Client: New Homes Inc.
Project: Smithfield - French Country - FE / LH
Address: 394 Duncans Creek
Lillington, NC
Harnett County

Date: 5/22/2025
Input by: Hampton Horrocks
Job Name: 158 Duncans Creek
Project #: J1124-6344

FJ13 BLI 40 11.875" - No Repair Required
See User Note 1

FJ9 BLI 40 11.875" - - No Repair Required
See User Note 1

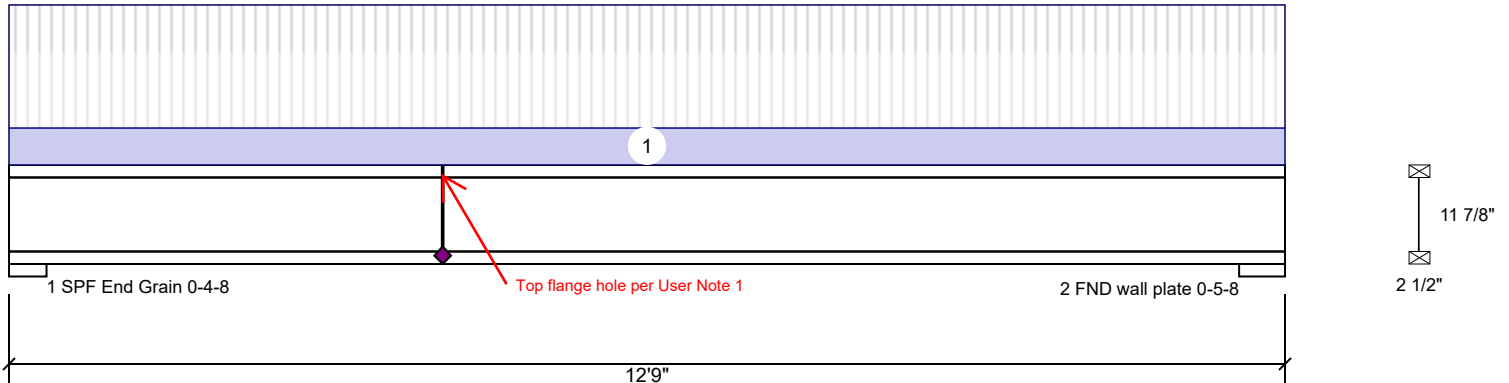
- Location Analysis represents a vertical hole through one leg of top flange. The web was not disturbed. This design based on scaling of provided photograph. No definitive cross-section dimensions of joist flange hole were provided. No repair required.

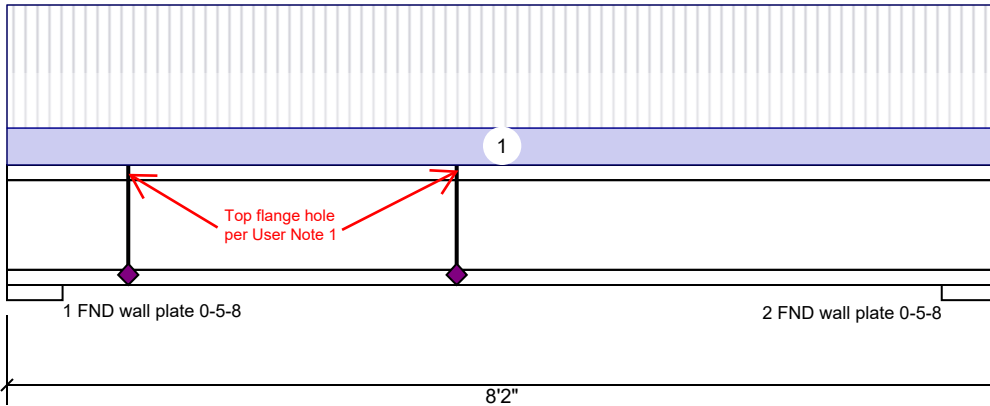
- Location Analysis points represent two vertical holes through one leg of top flange. The web was not disturbed. This design based on scaling of provided photograph. No definitive cross-section dimensions of joist flange holes were provided. No repair required.
